WOODHAVEN PARK PHASE 2

SHERWOOD, OREGON

BID SET

COVER SHEET
WOODHAVEN PARK PHASE 2
SHERWOOD, OREGON

ROMTEC PAVILLION DETAIL 1 OF 3
 WOODHAVEN PARK PHASE 2
 SHERWOOD, OREGON

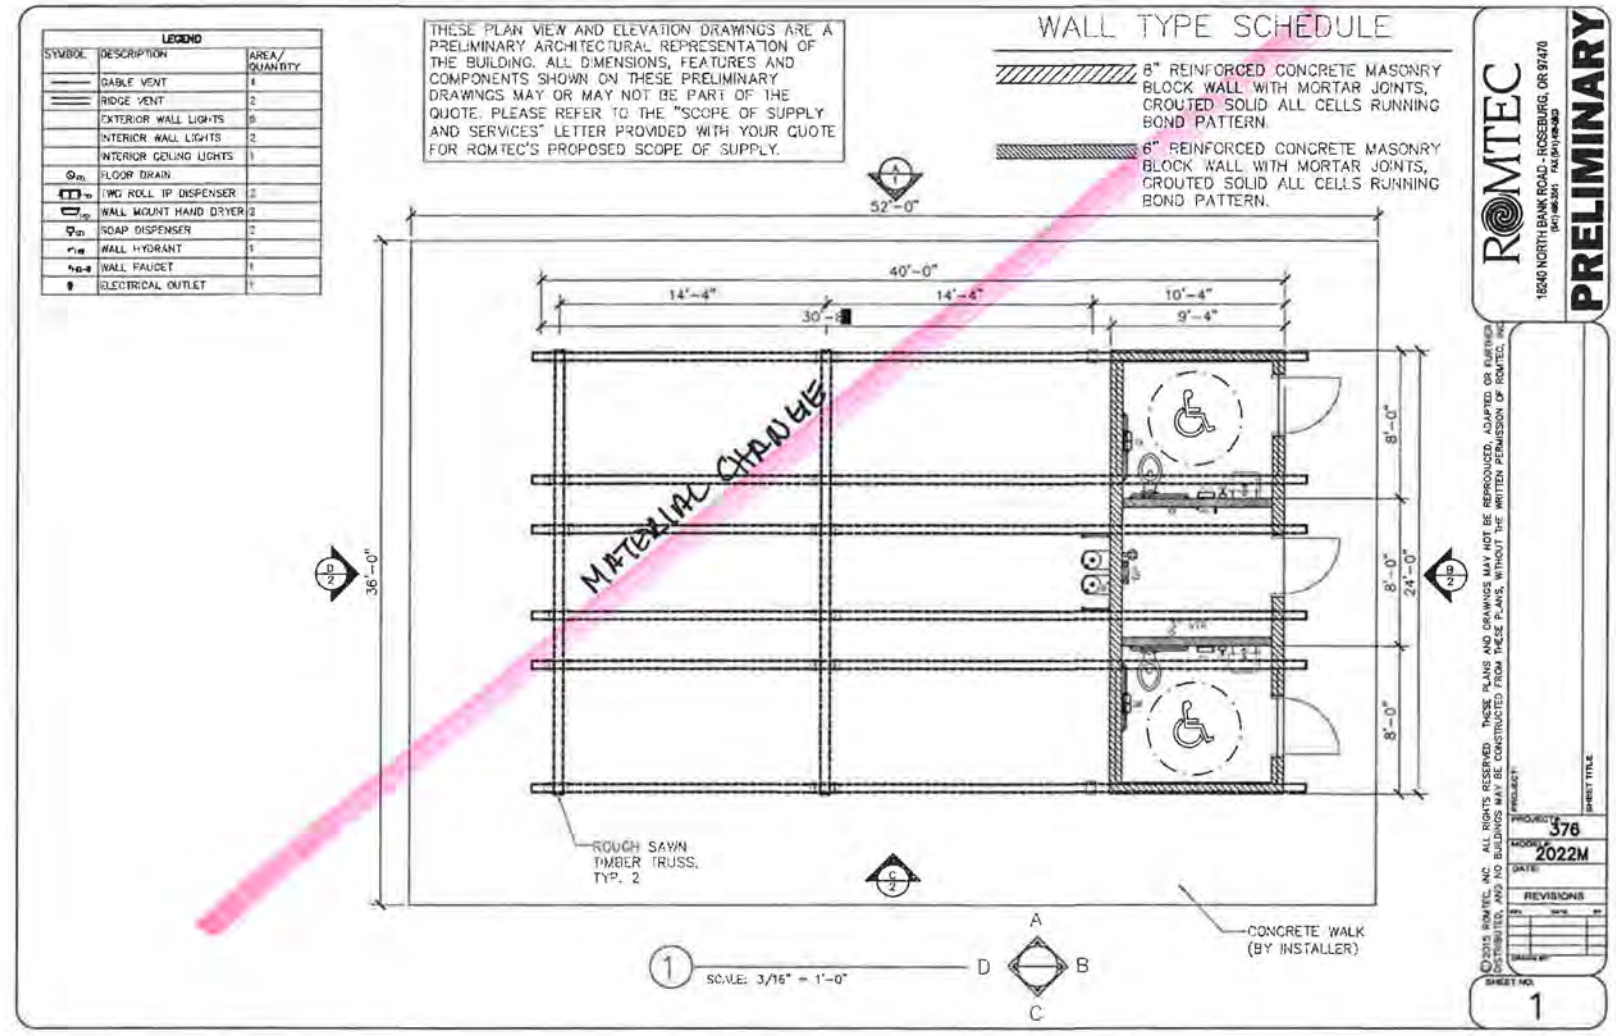
MATERIAL CHANGE

ROMTEC PAVILLION DETAIL 2 OF 3
WOODHAVEN PARK PHASE 2
SHERWOOD, OREGON

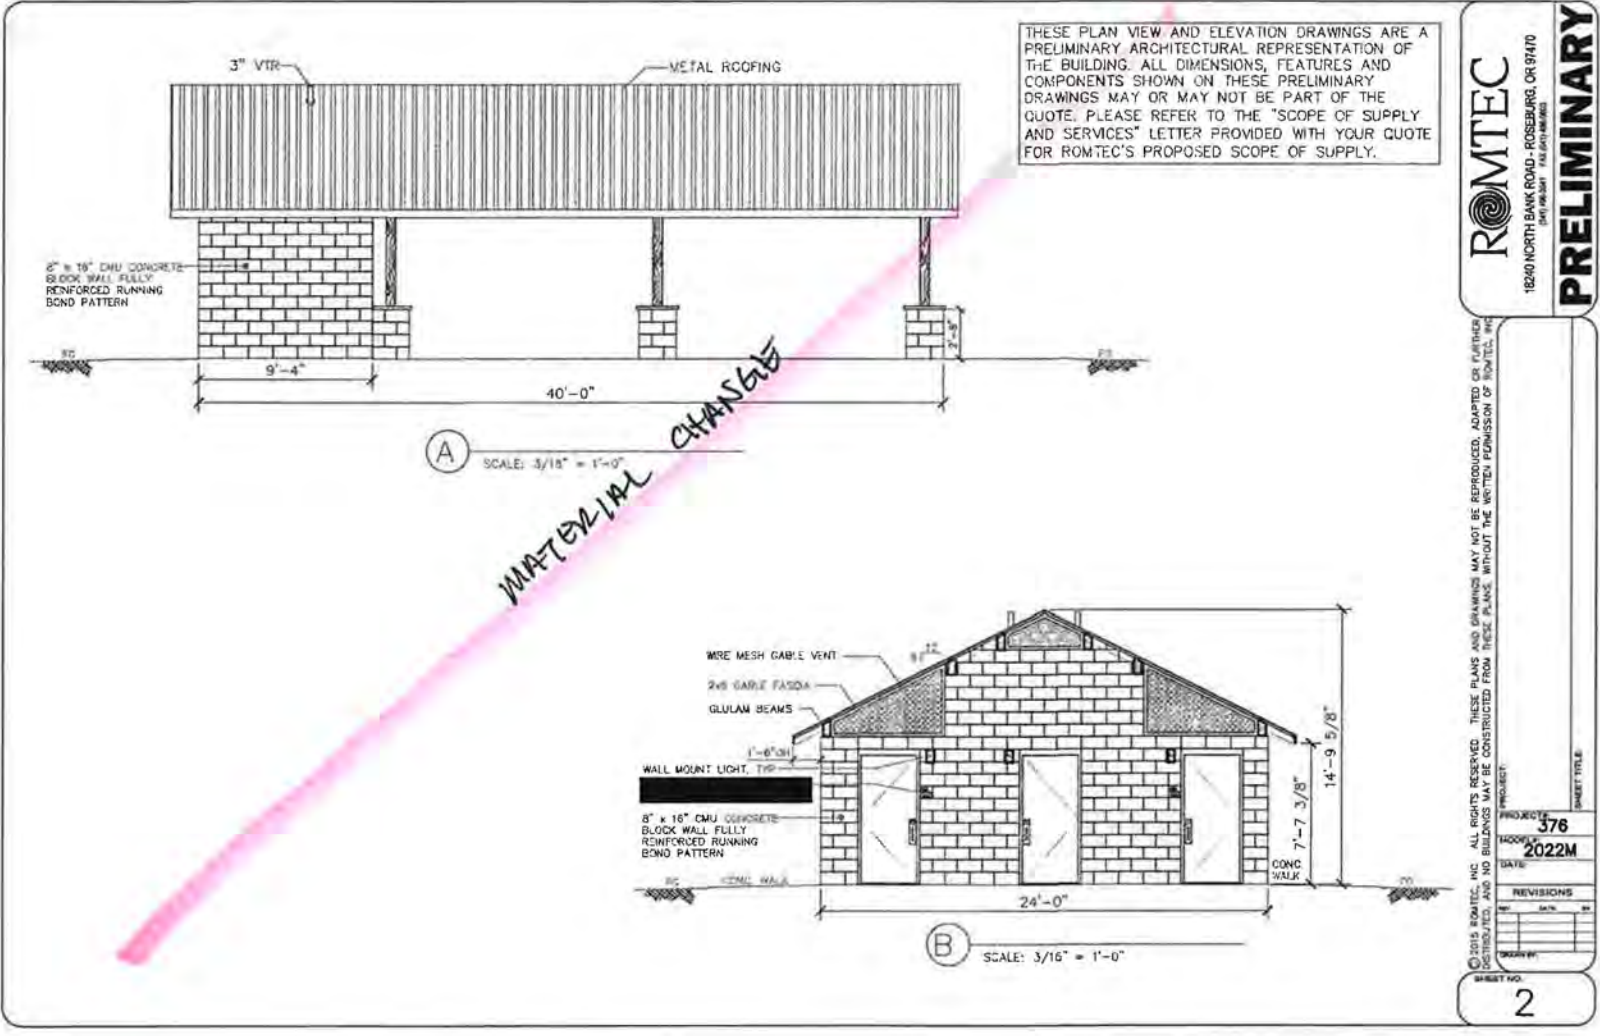
MATERIAL CHANGE
